SKYWARD
LAND SERVICES, INC.

Re: Notice of Exempt Modification – Generator Replacement Project
Site Location: 430 Middlesex Turnpike – Old Say Brook, CT
Site No: CT03XC102

EXISTING EQUIPMENT PLAN
FINAL EQUIPMENT PLAN
Sprint
SKYWARD
FULLERTON
CT03XC102
BU# 878336
OLD SAYBROOK
ENLARGED EQUIPMENT PLANS
C-3

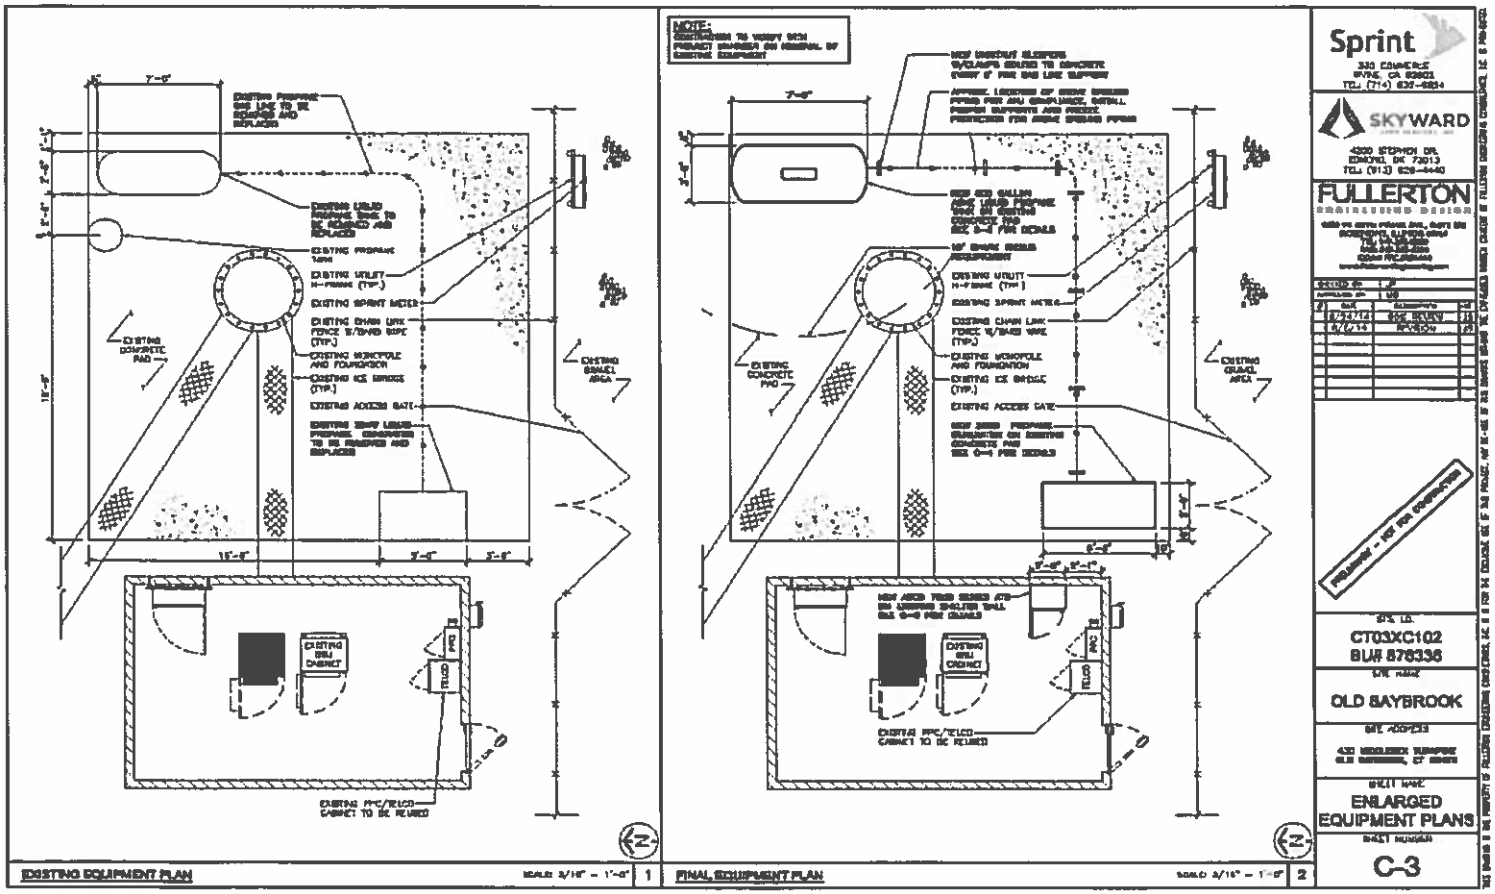
In an effort to further enhance Sprint's network reliability, Sprint intends to modify its facility by removing the existing generator and installing a new Generac QT-36-VP vapor generator in the existing place. Removing the existing propane tank and installing a new 500 gallon ASME tank in its current location. The replacement project will incorporate the replacement of all piping, valves, and regulators per AHJ compliance. Install of a new ASCO ATS switch inside shelter next to PPC and telco. *shelter site* Install proper support and freeze protection for above ground piping. (See Facility Compound Plan attached).
